Connection Assessment Report for Detweiler Shunt Capacitor Replacement

Connection Applicant: Hydro One Networks Inc.

CAA ID 2002-EX032

Final Report

Figure 1. Detweiler TS 230 kV Switch Yard

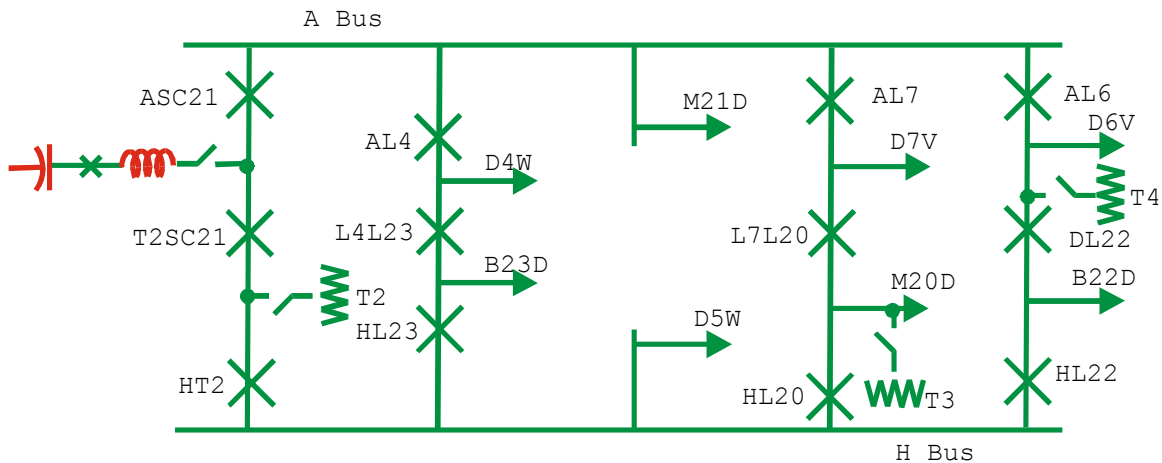
The Market Rules require that the voltage change upon switching of a capacitor bank not exceed 4%. Calculations, using the system short circuit levels provided by Hydro One from the 1999 short circuit survey, show that the switching of this low voltage capacitor will generate a voltage change of about 2.7%.

Because the capacitor units are not equipped with fast discharge resistors the successive switching off and on of this capacitor bank will have to be restricted to allow for the full discharge of the cans.

Auto switching capability will not be provided for this shunt capacitor installation.

The proposed installation of the 230 kV shunt capacitor bank at Detweiler TS is not likely to have any adverse impact on the reliability of the IMO-controlled grid.

It is thus recommended that notification of approval be granted for the installation of the 225 Mvar shunt capacitor at Detweiler TS.
